CCNPP3COLA PEmails

Subject: UniStar Nuclear Energy, NRC Docket No. 52-016
Submittal of Response to Calvert Cliffs Nuclear Power Plant, Unit 3
COLA, Request for Additional Information Terrestrial Ecology

Response to Terrestrial Ecology RAIs

**500' Buffer of the Chesapeake Bay Bluff Habitat That Is Utilized By
Tiger Beetles**

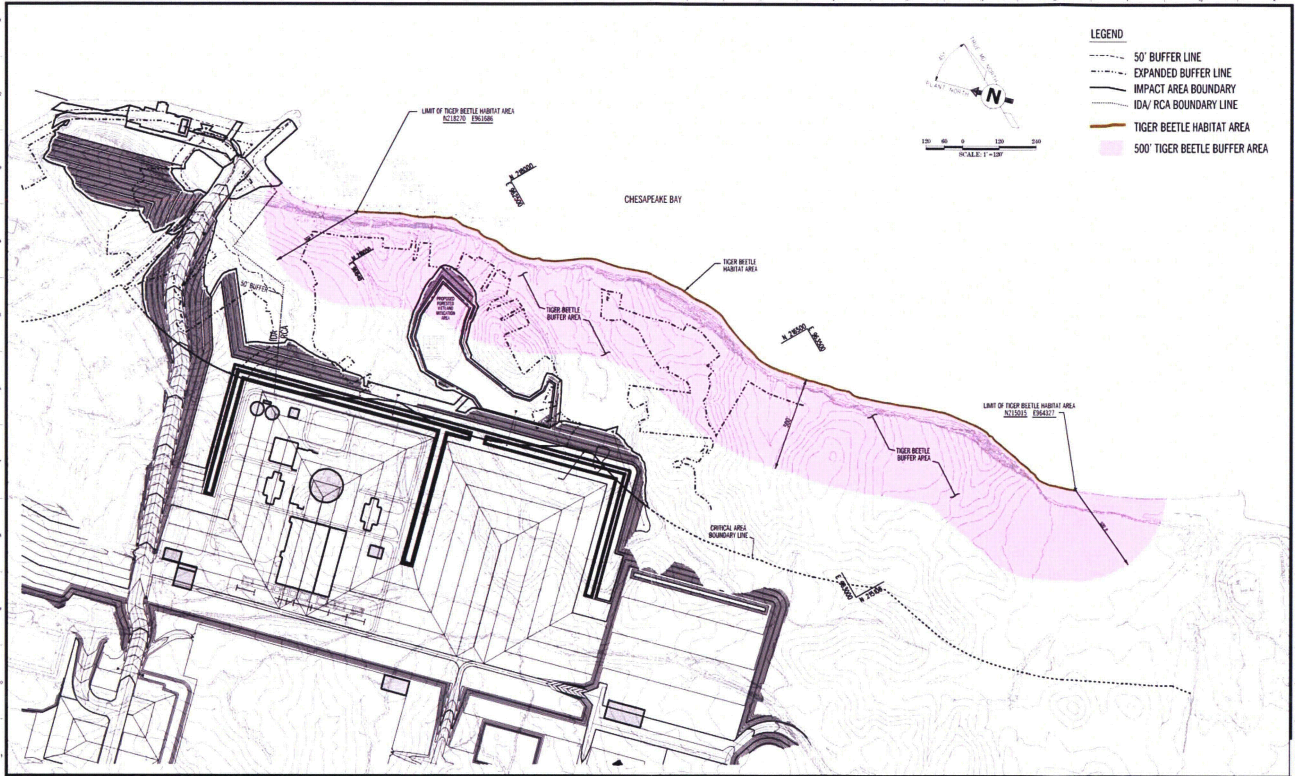
Provide a figure (e.g., a map) illustrating the 500' buffer of the Chesapeake Bay bluff habitat that is utilized by tiger beetles, and any encroachment within the buffer due to activities associated with proposed Unit 3.

Attachment 3 to this response provides a map illustrating the 500' buffer of the Chesapeake Bay bluff habitat that is utilized by tiger beetles, and any encroachment within the buffer due to activities associated with proposed Unit 3.
